## **Authors' Response to Comments by Anonymous Referee #3**

Fig.A Soil water content measured by different methods in 2011

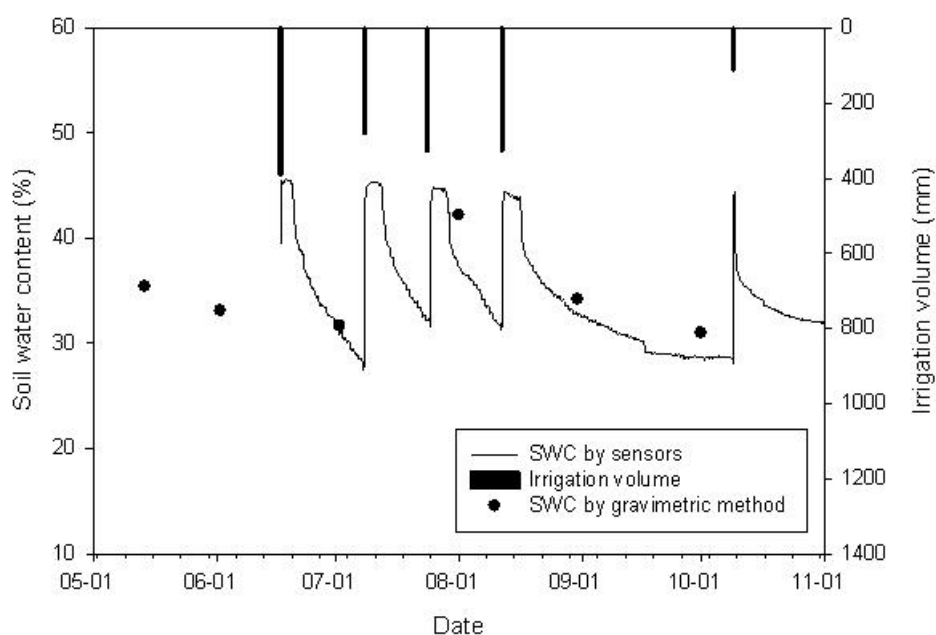
5. P1788 L5-10. Were the high changes in pore water conductivity due to brackish irrigation water accounted for in the estimates of volumetric water content using TDR methods? Please also present some of the raw data and report both the mean and uncertainty of the changes in water content with depth. Soil moisture is highly variable in space, how representative are the two profiles you instrumented to the larger study area? Difficult to trust EF value without first justifying changes in soil water content represent the entire field instead of 1 point in the 3.48 ha field.

We agree with the referee that the soil moisture is highly variable in space. We compared the soil water content results measured by different methods (Fig. A). The figure shows that the SWC results by soil sensors and gravimetric method agree well. Moreover, in this study, we only considered the change of soil water storage ( $\Delta S$ ) during water balance analysis. Therefore, although there will be huge spatial heterogeneity in SWC, the SWC change at each measured location is relatively consistent and reliable. Moreover, the error analysis including SWC uncertainties has also been shown in Section 4.5. In this study, the fresh water from the canals was used for irrigation rather than brackish water from the groundwater wells. Therefore, the effects of brackish water have not been considered.
